**Sub :** Design, fabrication, supply and erection of Pre-Engineered steel buildings for stabling shed-2 and station platform shed at Aarey depot of Mumbai Metro Line-3 (Colaba-Bandra-SEEPZ) Project

**Name of work :** Design, fabrication, supply and erection of Pre-Engineered steel buildings for stabling shed-2 and station platform shed at Aarey depot of Mumbai Metro Line-3 (Colaba-Bandra-SEEPZ) Project

**(Reply/Clarification of Bidder's queries)**

Addendum no. 1

**Drawing Title :**  
 MUMBAI METRO LINE-III AREY DEPOT  
 COVERED STABILING SHED 2  
 GROUND FLOOR PLAN

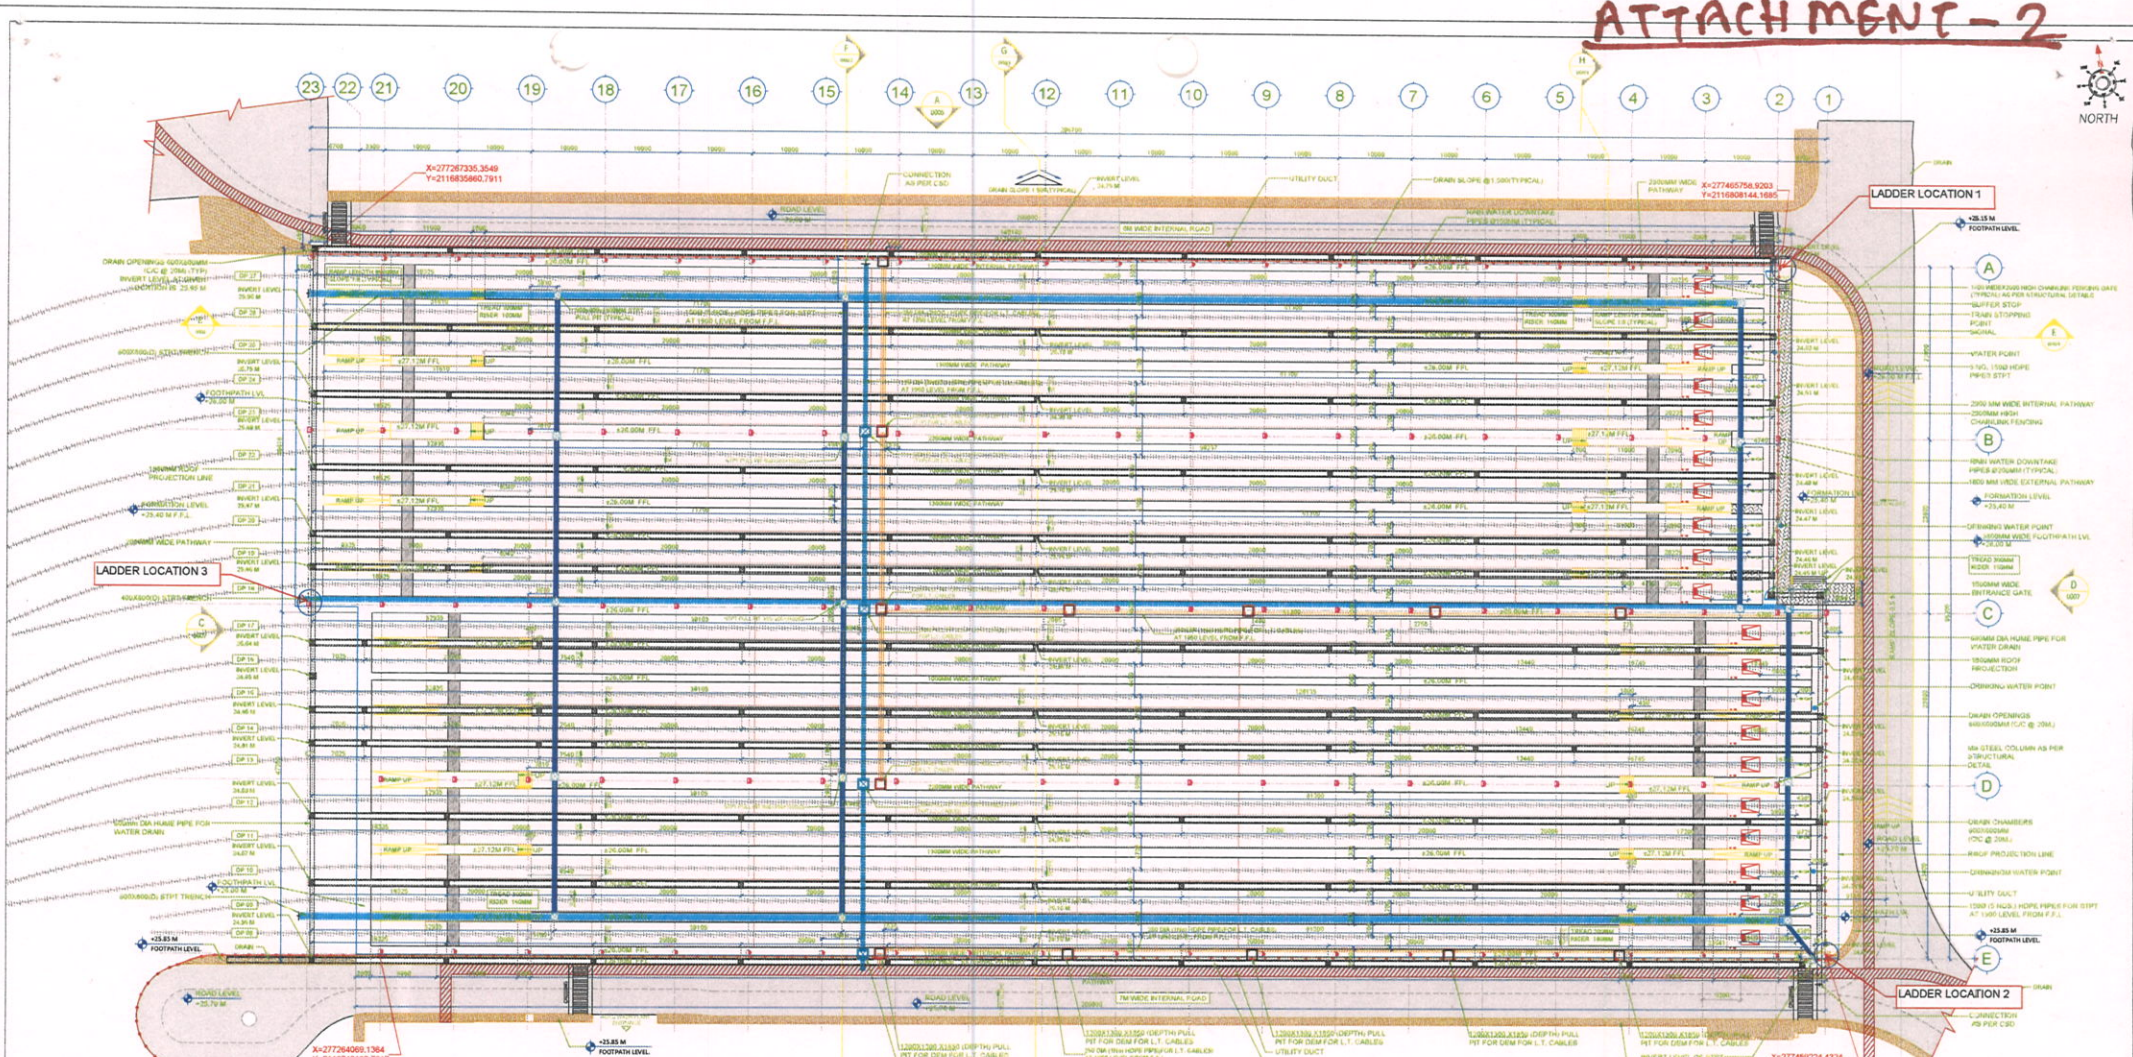
5	Vol.4 Page No 48	Clause no 9.1.6	Material Specification		1. Type of Purlin to be used. Whether it will be galvanized or painted?	ISMC purlins painted as per tender specification shall be used. Z purlins are not permitted.
6	Vol.5	Stabling Shed-2 GROUND FLOOR PLAN Drawing No- DEPOT- ARP-D05- 0001	Drawing		1. No. of Staircases, Cage ladder required for roof access and its location to be confirmed along with its technical specification.	3 Nos. of ladders without cage are required. These are of 600 mm width. (2 ladder on the rear end corner columns and 1 in the front middle column). Drawing attached for clarity (Ref: Attach-2)
7	Vol.5	AAREY DEPOT Station Platform shed	Drawing		1. No. of Staircases, Cage ladder required for roof access and its location to be confirmed along with its technical specification.	Not required, access shall be from the RCC building.
8	Vol.4 Page No.53	Clause E 1.16 & E 2.10 -	Interfaces between Depot PEB – Depot Civil/ Architectural finishes Contractor S. NO PEB- DCF-2		1. Grouting is under PEB Scope or Civil scope?	Grouting shall be in Depot Civil contractor's scope
